Access Compliance Report

Public Rights-of-Way

(Curb Ramps)

Intersection ID: N/A	Main Street: E_JOHN_BELK_RA	Cross Street: E_STONEWALL_ST	Location: E
ADA ID: 8E7572AB227D	Ramp Type: Perpendicular Diagonal	Initial Pass/Fail: Pass	Overall Compliance: No
Severity Score: 5.25			
Codes/Mitigation Info/Possible Solution		Field Measurements/Component Compliance

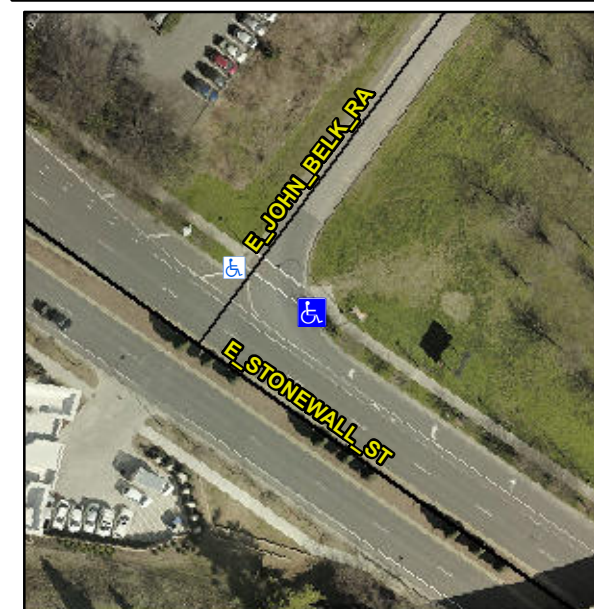
Not Found, R304.5.3, R304.2.1, R304.2.2-Perp, R304.3.2-Para, R304.5.4

Compliance	Description	Data	Compliance	Description	Data
N/A	Ramp Length (in)	71.0	Yes	Ramp Slope (%)	7.0
Yes	Ramp Width (in)	48.0	No	Ramp XSlope (%)	3.8
N/A	Flare Type LT	Sloped	N/A	Flare Type RT	N/A
N/A	Flare Slope LT (%)	3.9	N/A	Flare Slope RT (%)	10.8
N/A	Flare Traversable LT?	No	N/A	Flare Traversable RT?	No
Yes	Landing Length (in)	71.5	Yes	DWS Provided?	Yes
No	Landing Width (in)	44.5	Yes	DWS Contrast?	Yes
No	Landing Slope (%)	3.9	Yes	DWS Length (in)	24.0
Yes	Landing X Slope (%)	0.5	Yes	DWS Full Width?	Yes
N/A	Landing Curb? (Y/N)	No	Yes	DWS Offset (in)	1.0
N/A	Shared Landing?	No			
Yes	Gutter Ponding?	No	No	Gutter Slope (%)	5.7
Yes	Gutter Lip Ht (in)	0.0	No	Gutter X Slope (%)	2.3
N/A	Painted X Walk1?	Yes	N/A	Painted X Walk2?	No
	X Walk 1 Direction	To NE		X Walk 2 Direction	To NW
N/A	X Walk 1 Width (in)	97.0	N/A	X Walk 2 Width (in)	N/A
	X Walk 1 Slope (%)	0.5		X Walk 2 Slope (%)	0.8
	X Walk 1 X Slope (%)	3.3		X Walk 2 X Slope (%)	1.7

Remove & Replace Curb Ramp With Two New Directional Ramps or Equivalent. Remove & Replace Gutter.
